**SERVICE BULLETIN:**  
**EFL5550**  
**Wing Center Section Bulletin:**

July 1, 2016

**Product:** Radian XL 2.6m BNF Basic (EFL5550) Wing Center Section Bulletin

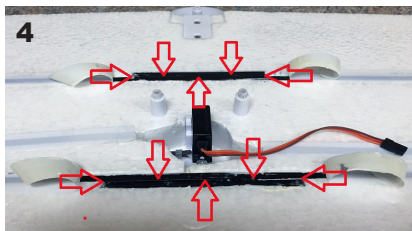
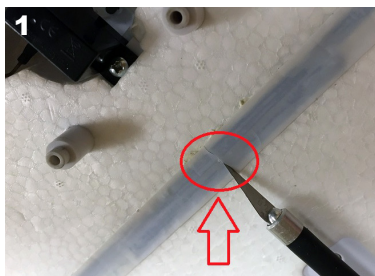
**Issue:** The spars and doublers may be loose.

**What To Do:** If there is no colored sticker located on either the outside of the product box near the UPC/barcode or on the bottom of the center wing panel, perform the steps below.

1. Use a hobby knife to carefully cut the white tape covering the spars and doublers on the bottom of the wing. DO NOT cut the spars and doublers.
2. Peel back the white tape to partially expose the spars and doublers.
3. Use a small flat head screwdriver to spread the joint between the spars and doublers. If you cannot spread the joint, move to Step 4.
4. Apply a thin layer of CA to (1) the corners where the doublers come into contact with the spars and (2) in/on top of the joint between the doublers and spar.
5. Press the white tape back down after the glue sets/dries.

*Required: Thin CA (Cyanoacrylate) glue (odorless/foam-safe CA and the use of accelerator is not recommended), a hobby knife, and a flat head screwdriver.*
